**Before the
FEDERAL COMMUNICATIONS COMMISSION
Washington, D.C. 20554**

In the Matter of)	
)	
Wireless Telecommunications Bureau Seeks to)	GN Docket No. 12-268
Supplement the Record on the 600 MHz Band)	
Plan)

COMMENTS OF CTIA – THE WIRELESS ASSOCIATION®

June 14, 2013

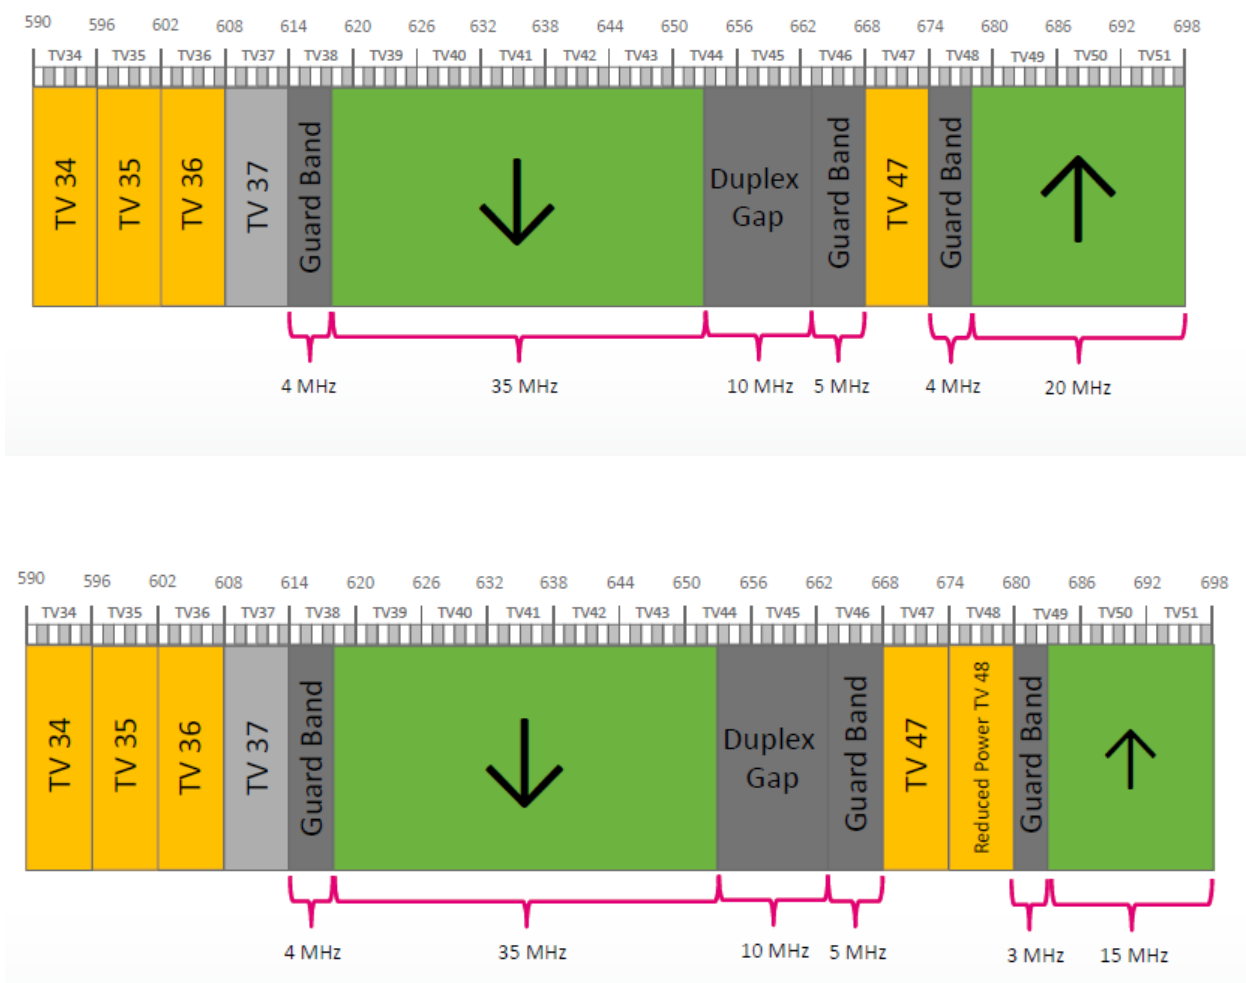
CTIA believes that the Commission has mistaken parties’ acknowledgment of potential market variability for an endorsement of television stations in the duplex gap. Specifically, the Commission points to a filing by T-Mobile in support of its finding that television stations could be placed in the duplex gap in constrained markets.³⁰ CTIA has provided two examples from the T-Mobile filing below:

The FCC appears to believe that the TV 47 and TV 48 operations shown in these figures are indicative of TV operations within the duplex gap. However, as can be seen above, the duplex gap is clearly specified as being in the 653 to 663 MHz band in both figures. In none of the representative band plans provided by T-Mobile are there TV operations in the actual duplex gap, but instead (in cases where various amounts of spectrum are cleared) there is a suggestion that some TV operations could be allowed in the mobile uplink pass band, not the duplex gap. What some parties have observed is that “[i]n markets with very low clearing, it may be possible to allow TV stations in the *uplink or downlink pass bands*.”³¹ For example, as depicted in the

figures above, the T-Mobile proposal cited by the Commission maintains a fixed 10 MHz duplex gap but provides for broadcast operations in the uplink pass band in those markets where 13 or fewer channels are cleared.³² Such an approach would be similar to the Commission’s concept of band plan “families” in which differential receive filtering would be enabled in the base station to accommodate variations in the amount of uplink spectrum.³³ Qualcomm describes this approach containing TV stations entirely within the uplink band-- “provid[ing] strong attenuation of the TV signal from the duplexer’s downlink band filter and offer protection of the downlink receive path,”³⁴ a far preferable outcome to the interference scenario with television in the duplex gap. Qualcomm notes that this “sub-optimal approach”³⁵ should be avoided because such an approach “creates additional guard bands and buffer zones that may extend into adjacent markets.”³⁶

gap. From that starting point, the downlink spectrum is built out. The issue that remains is the co-channel interference protection between markets with varied amounts of spectrum, not the use of the duplex gap for TV operations as well as the amount of guard bands needed to protect wireless operations from harmful TV interference (as is shown in the first figure above for the T-Mobile band plan where there are guard bands needed surrounding TV 47).

Therefore, for the "Down from 51" approach favored by the wireless industry, market variability in spectrum made available can be handled by allowing limited use of the uplink (or downlink) pass band for TV station operations. However, this outcome should not be the normal operating environment; it should only be used in the cases where the Commission is unable to clear sufficient spectrum for efficient pairing of the reallocated TV spectrum. As noted in the T-Mobile figures above, use of the uplink (or downlink) pass band in this fashion will require additional guard bands in those unusual markets as well as "buffer zones" between markets that may have TV operations and those that have wireless operations in the same spectrum bands.
